FEDERAL TRANSIT ADMINISTRATION

CLIN 0005: Spot Report
Spot Report #1: Cost Validation Report

Honolulu High-Capacity Transit Corridor

Cost Validation Report
May 2007

Exhibit III-1
Variance Analysis: By Cost Category
Honolulu "New Starts Project"
(Fully Allocated Contingencies)

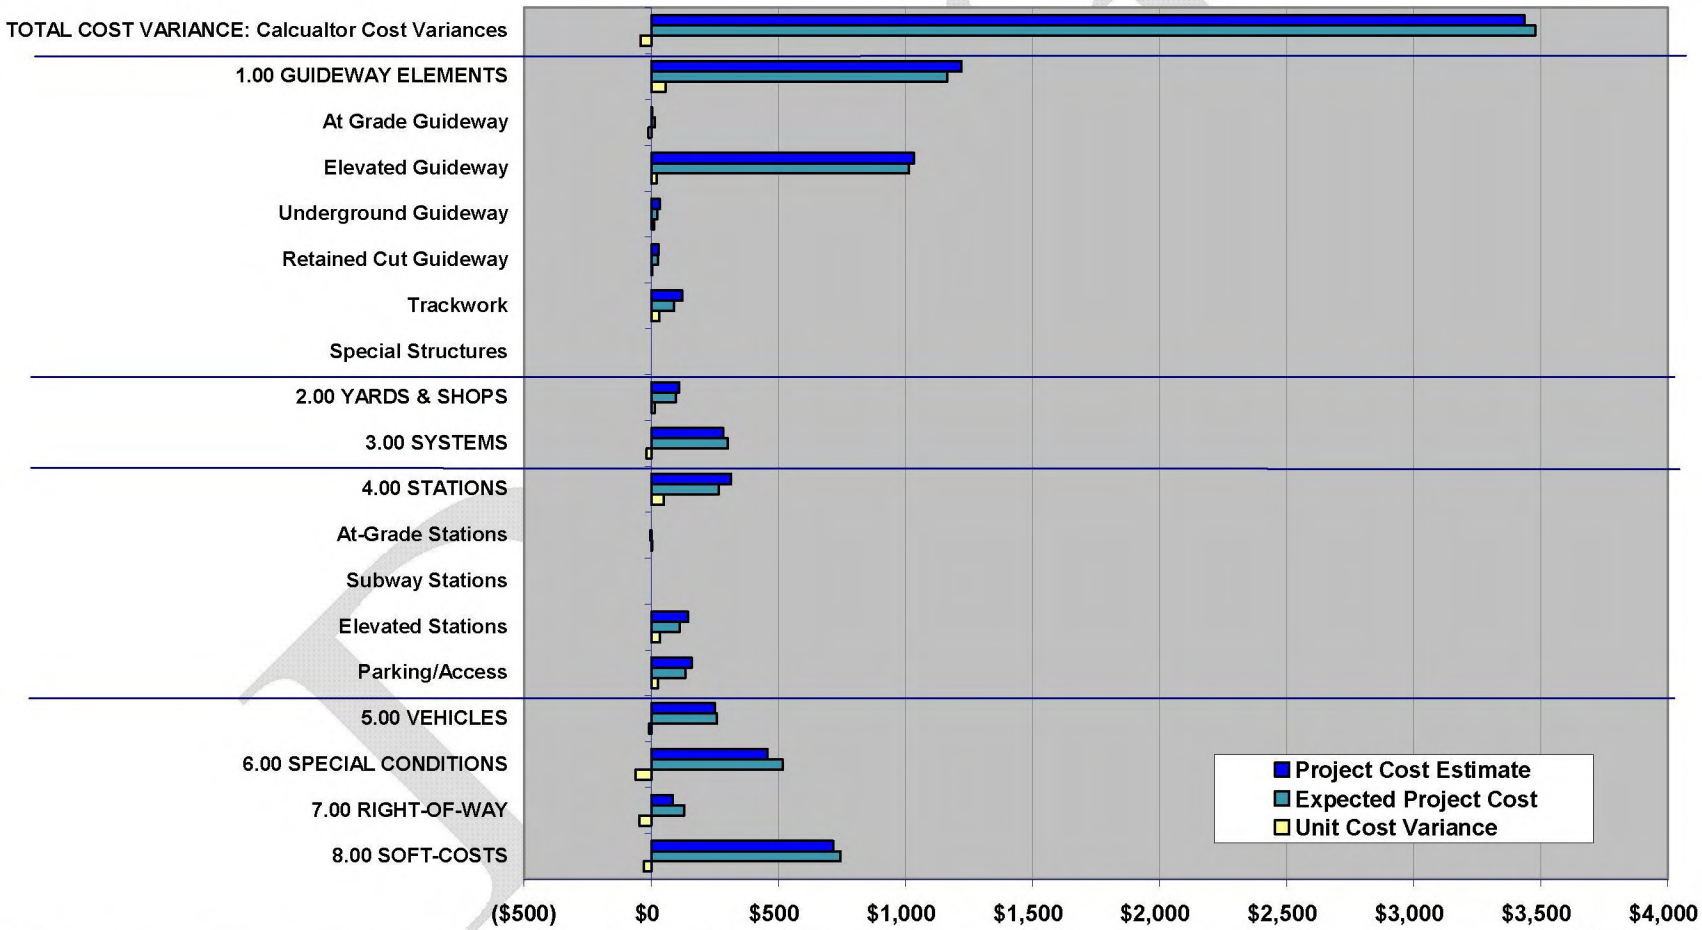
The results of the top-down cost validation analysis are presented graphically in Exhibits III-1 and III-2 (above) and as a table in Exhibit III-3 (below). For the project as a whole, as well as for each cost category and several major category elements, Exhibit III-1 presents:

1. The actual project cost estimate for a given category or element;
2. The *expected* cost of that category or element based on the historic costs from the cost database (i.e., average historic unit cost * project unit quantity); and,
3. The difference or "unit cost variance" between these two values (i.e., project cost estimate minus the expected cost). Note that this is a "unit cost" variance as the *quantities* are the same for the project and expected cost estimates, however the unit costs (expected and project actual) are different.

Total Project Cost: The top-down analysis suggests that the current project cost estimate for the New Starts definition of the High-Capacity Transit Corridor is roughly $42 million, or roughly 1.2%, lower than the project's expected cost based on the sample of projects recorded in FTA's Capital Cost Databases. As discussed further below, the negative cost variances for special conditions (including utility relocations, roadway changes, demolitions and environmental mitigation), right-of-way acquisition, and soft-costs are the prime drivers of the slightly less than expected project cost (based on prior cost experience). In contrast, the current project cost estimates exceed the database predicted values for guideway elements (track and structure), yards & shops, and stations.

Exhibit III-2
Variance Analysis: By Cost Category
Honolulu "New Starts Project"
(Fully Allocated Contingencies)

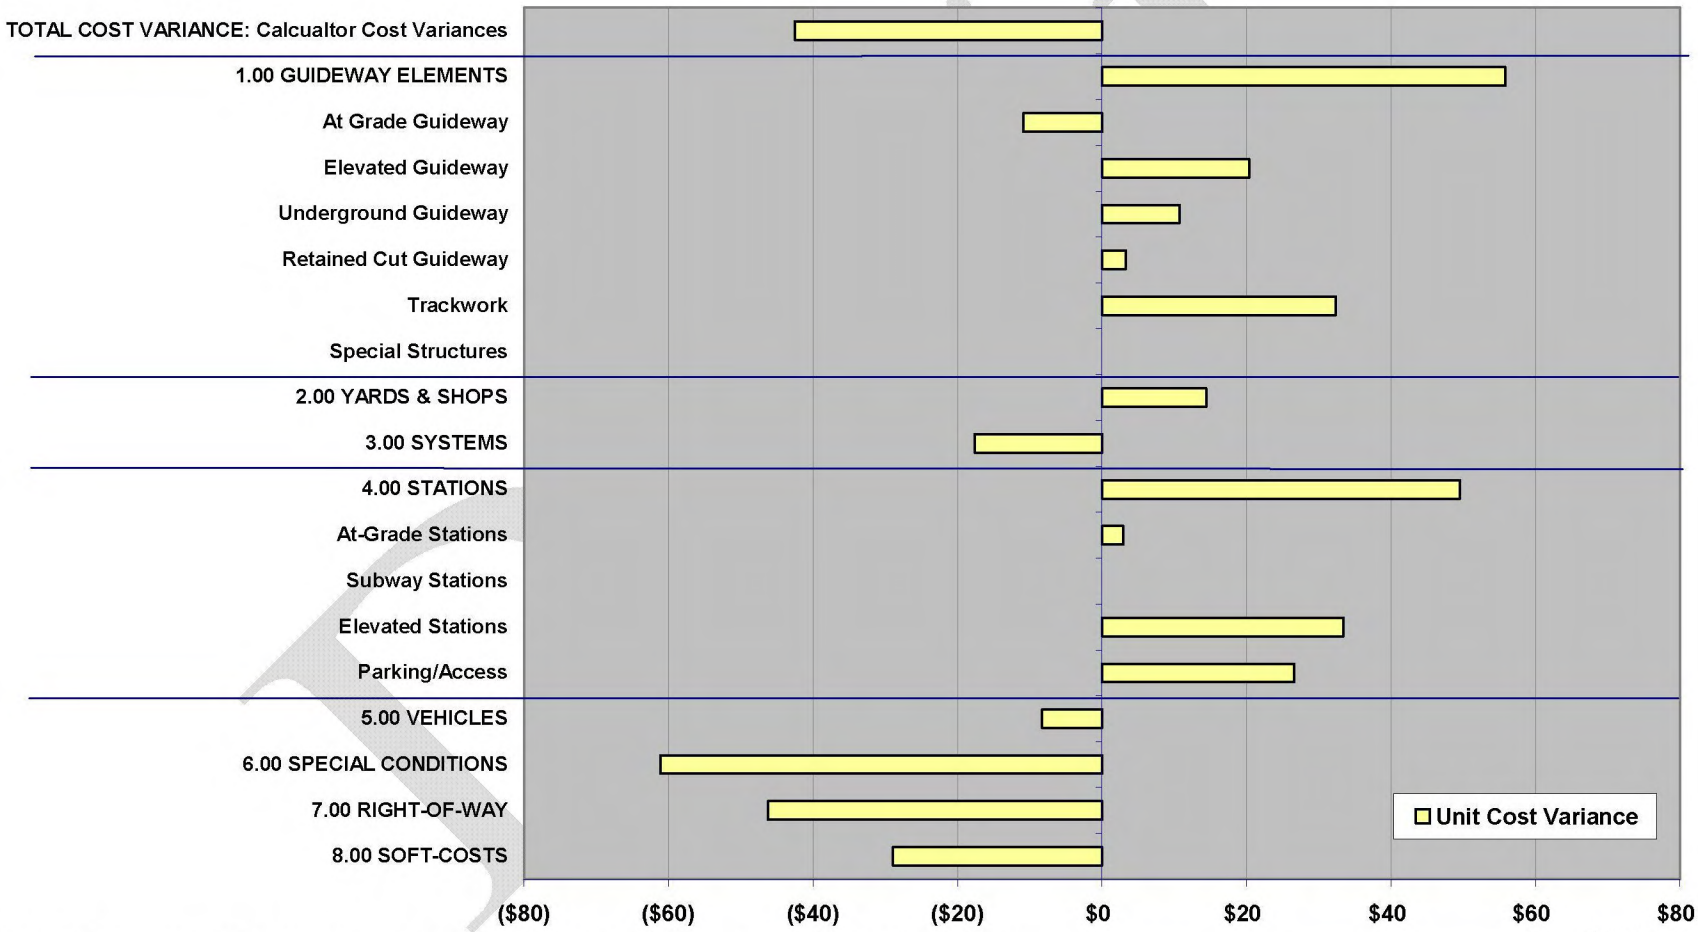
In contrast, Exhibit III-2 presents only the cost variances, which helps focus attention on those cost categories with the greatest cost variances. Exhibit III-3 presents the cost values behind all of these results in tabular form. Following are analyses of the results presented in these exhibits, beginning with a discussion of the individual cost categories then followed by an assessment of the total project cost:

Therefore, the fact that special conditions, ROW, and soft-costs account for much of the negative cost variation in Exhibits III-1 through III-3 (i.e., between the project cost estimates and the historical database values) is not unusual, but still grounds for further investigation. As discussed further below (under project risk), follow-on analysis has identified additional reasons for suspecting that the cost estimates for these cost categories may be underestimated and the Honolulu High-Capacity Transit Corridor Project team may want to revisit these cost estimates (in particular those for special conditions and right-of-way acquisition) as they move towards PE.

Exhibit III-4

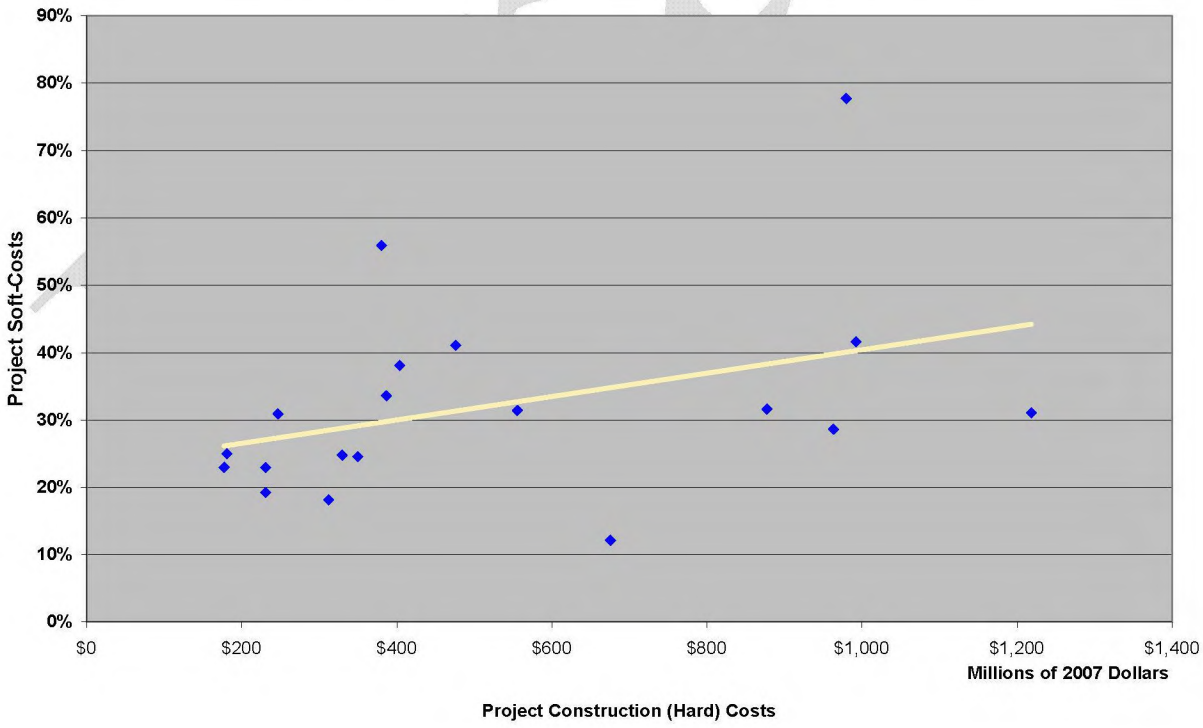
8.0 Soft-Costs: Project soft-costs include the cost of PE, final design, construction management, project management and oversight, finance charges, and training, testing and start-up. The project cost estimates of $715.7 million for soft-costs were found to be close to $30 million, or roughly 4%, lower than expected based on the sample of projects in the FTA cost database. Project staff justified this lower cost on the basis that projects whose costs are dominated by high expense items such as long aerial or subway alignment investments tend to have lower soft-cost expenditures (when expressed as a percent of hard costs). However, if anything, the relationship between soft costs and other project costs is a positive one based on analysis of the rail projects documented in the FTA Light and Heavy Capital Cost databases. In other words, not only do *total* soft-costs increase as project construction costs increase, but soft costs also account for an increasing (not decreasing) share of total project costs as project construction costs increase. This relationship is presented below in Exhibit III-4.
